DEVELOPMENT APPLICATION ASSESSMENT REPORT

Application Number:	DA2021/2405
----------------------------	-------------

Responsible Officer:	Maxwell Duncan
Land to be developed (Address):	Lot 15A DP 31138, 14 Ernest Street BALGOWLAH HEIGHTS NSW 2093
Proposed Development:	Demolition works and construction of a dwelling house and swimming pool.
Zoning:	Manly LEP2013 - Land zoned R2 Low Density Residential
Development Permissible:	Yes
Existing Use Rights:	No
Consent Authority:	Northern Beaches Council
Land and Environment Court Action:	No
Owner:	James William Barchard Martin Kathryn Ann Martin
Applicant:	Kieran Burns

Image 1- First floor balcony.

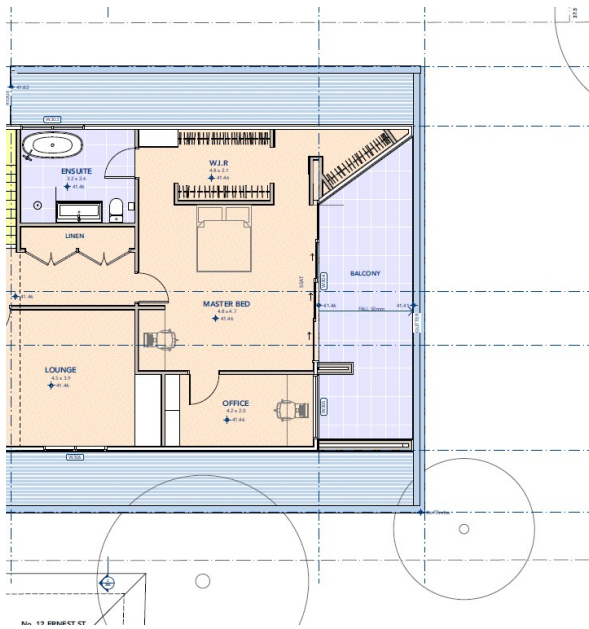
The application proposes two outdoor living areas to the rear of the dwelling house, a deck at ground floor level and balcony at first floor level. The deck and balcony at both levels are extensive and extend the length of the northern elevation of both levels. To mitigate privacy to the adjoining properties to the east and west, the applicant has included screen along the eastern and western edge of the living areas. The proposed screening will mitigate direct sightlines to the adjoining properties private open space. While there may be some sightlines to the rear yard of both adjoining properties from the both levels, it is considered to be direct overlooking. The expectation of complete privacy is unreasonable in this residential setting. Reasonable level of privacy are retained. No further privacy mitigation measures are required in this instance.
